SFMTA - TASC SUMMARY SHEET

Location: Eddy and Jones

Subject: Police Vehicle Parking

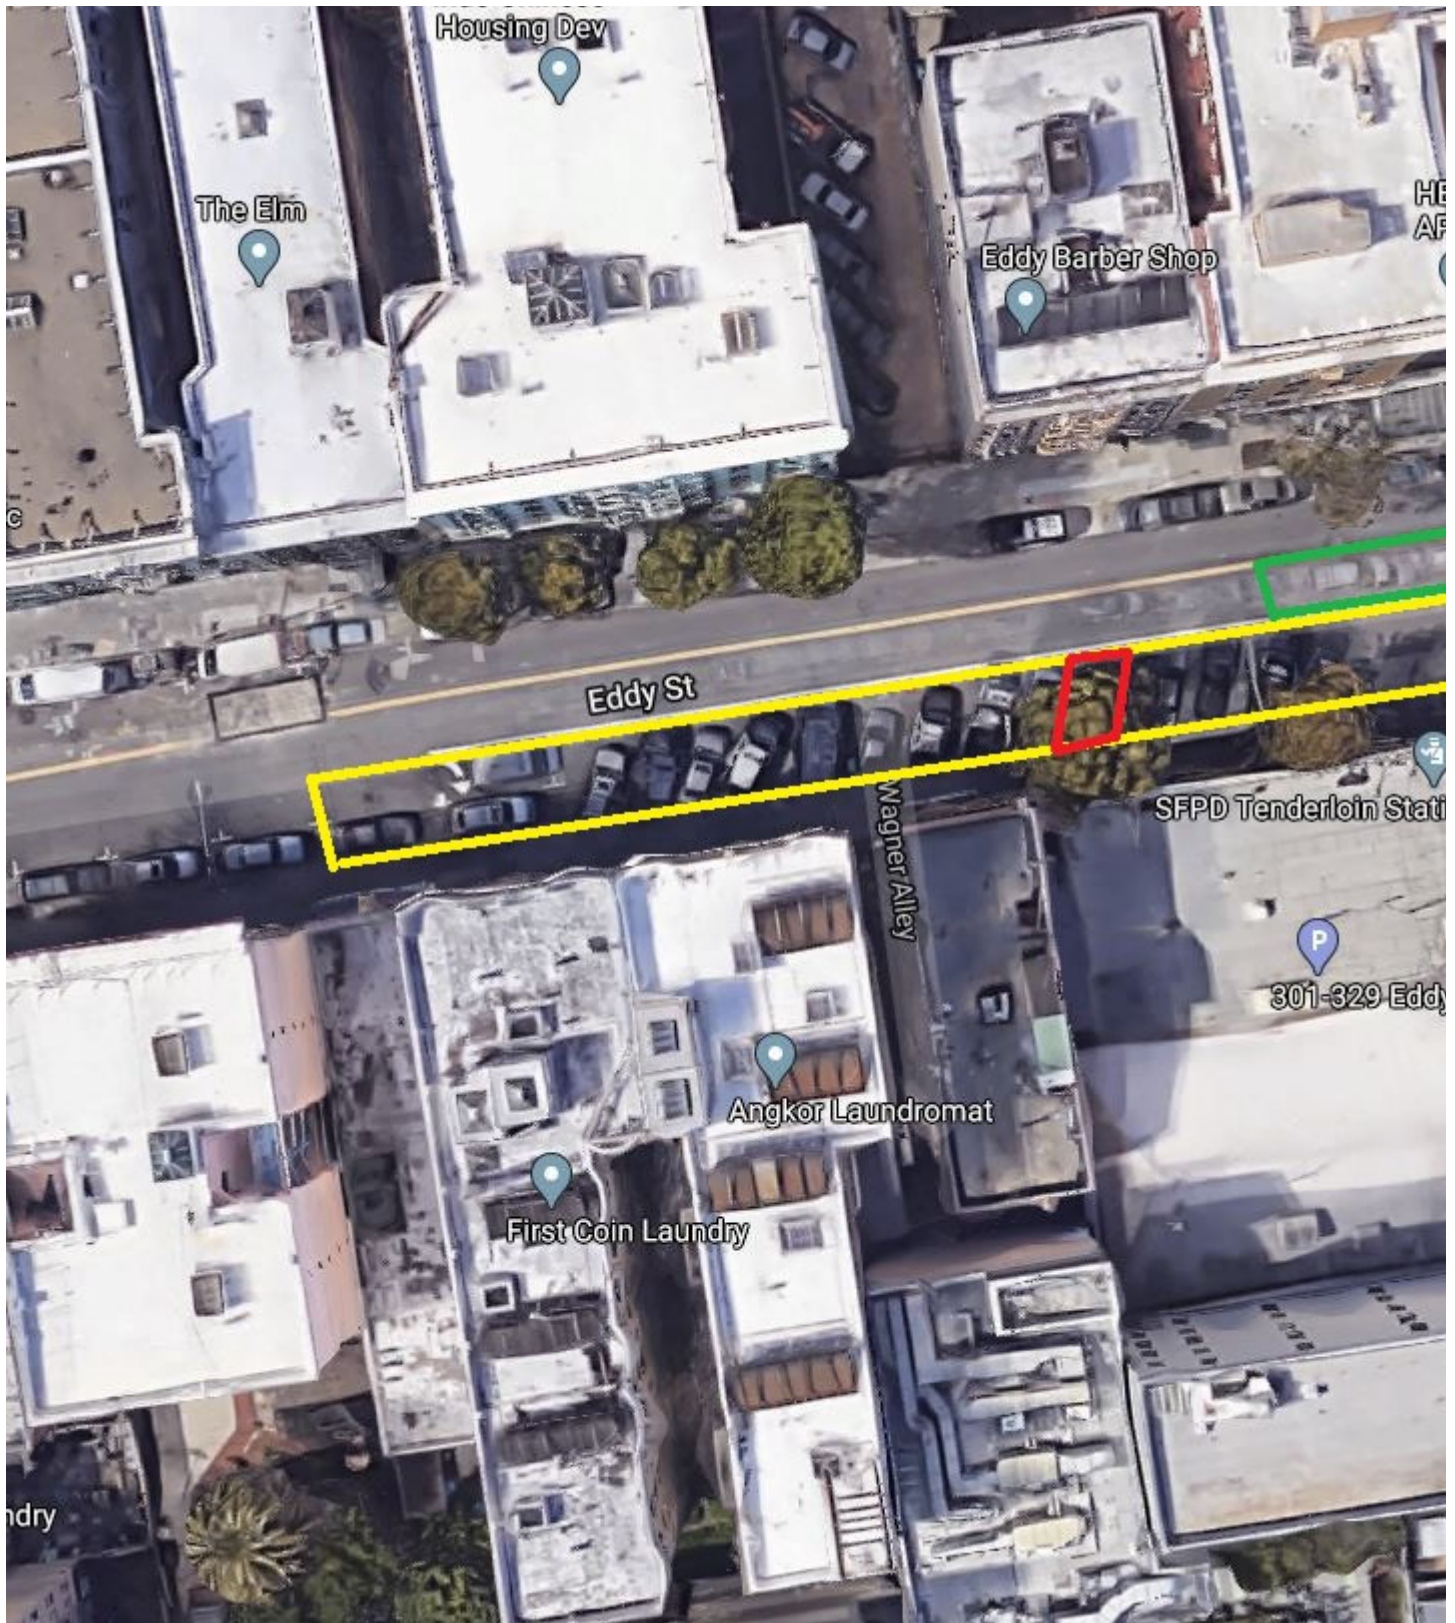
- 1) Highlighted in yellow: SFMTA will rescind the EB right-turn only lane on Eddy and extend the zone on the south side of Eddy for police parking only.
- 2) Highlighted in red: SFPD will avoid parking in front of the fire hydrant (adjacent to the station's westernmost door) so that the curb can be used for ambulances and prisoner pickup/drop-off when necessary, thereby discouraging double parking on Eddy.
- 3) Highlighted in green: SFMTA will paint a ~60-foot KEEP CLEAR zone near the stations garage entrance/exit. SFPD will concentrate the parking of radio units near the KEEP CLEAR to increase flexibility in Code 3 response.
- 4) SFMTA will extend police parking in front of 241 Jones.

Meter Drawing (Eddy)

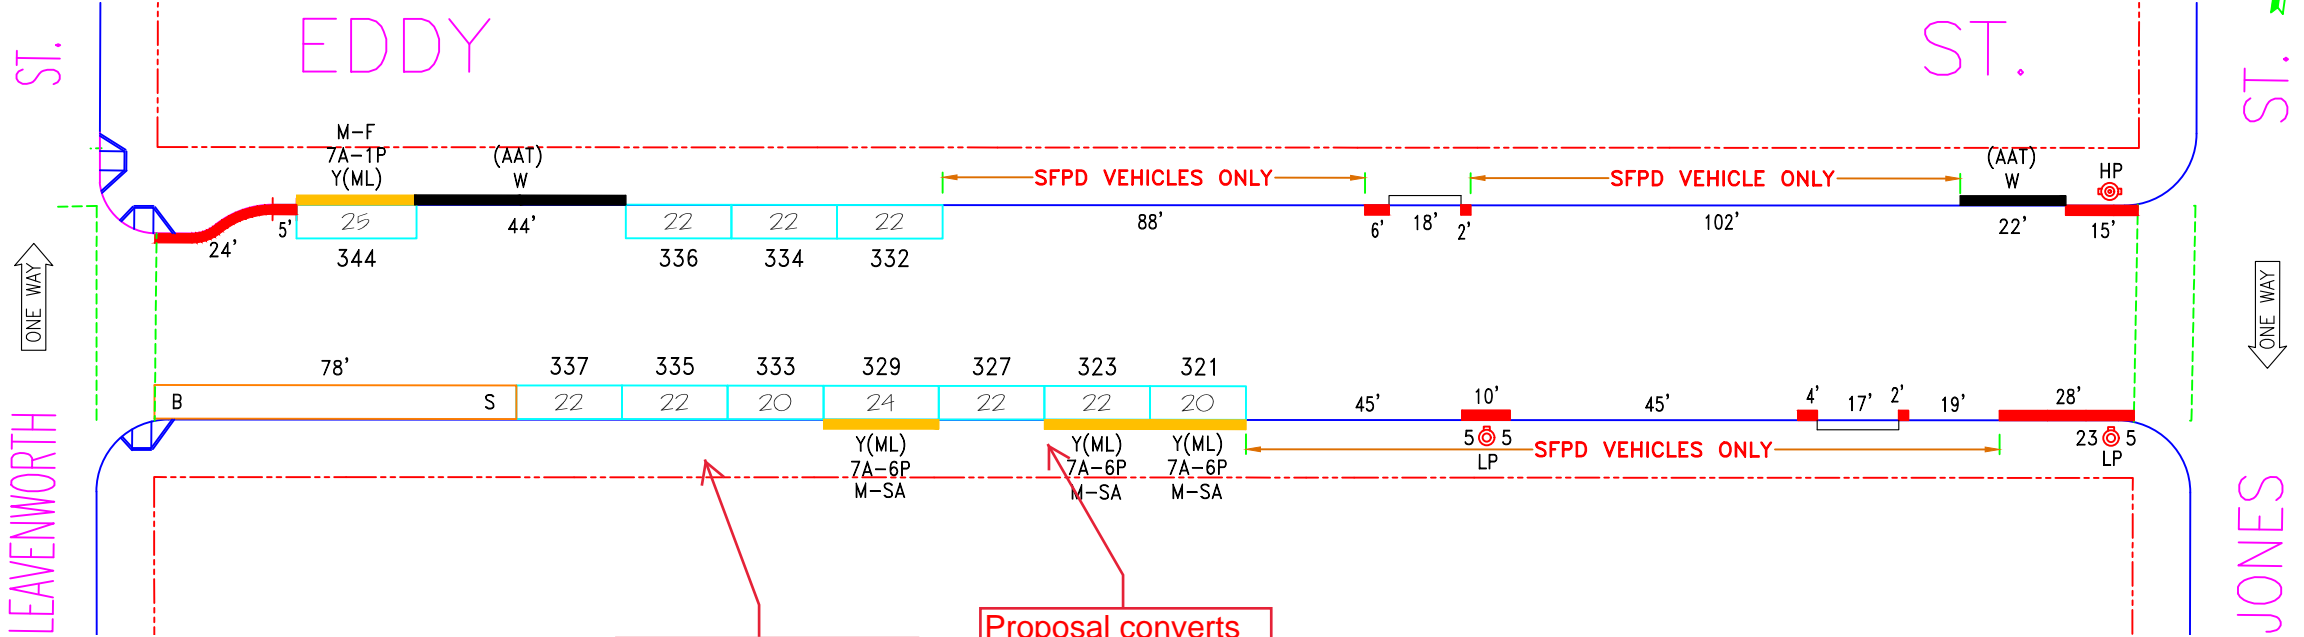
Proposal converts meters 337 and 335 yellow loading meters

Proposal converts meters 329, 327, 323, 321 to SFPD parking.

AREA
2

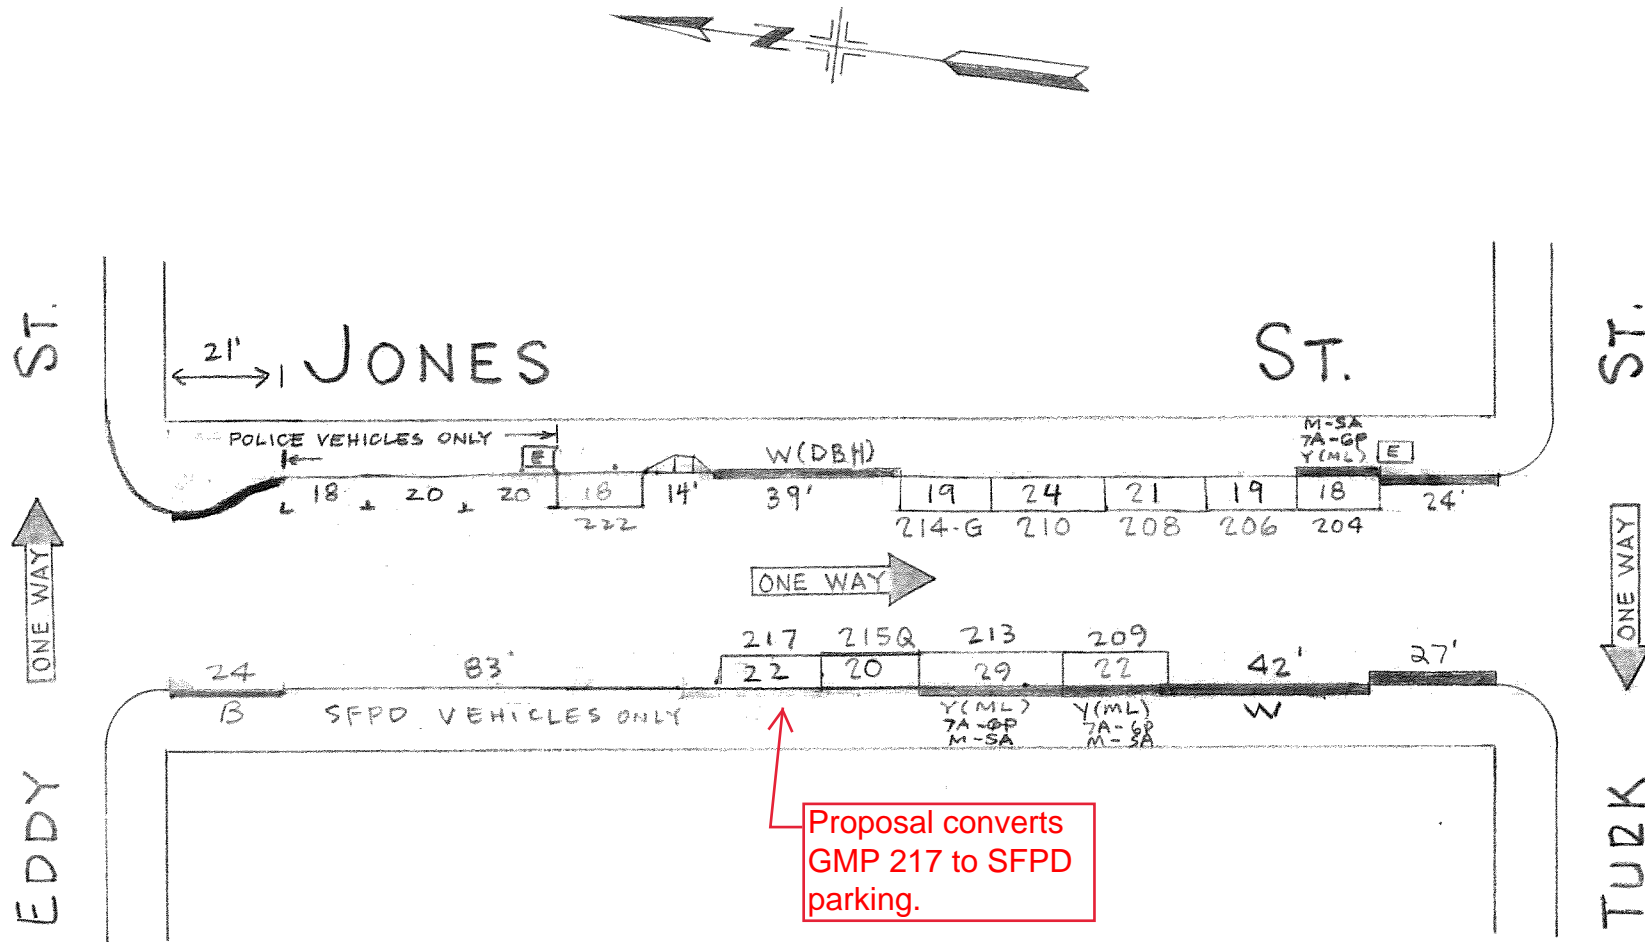
Proposal converts GMP 217 to SFPD parking.
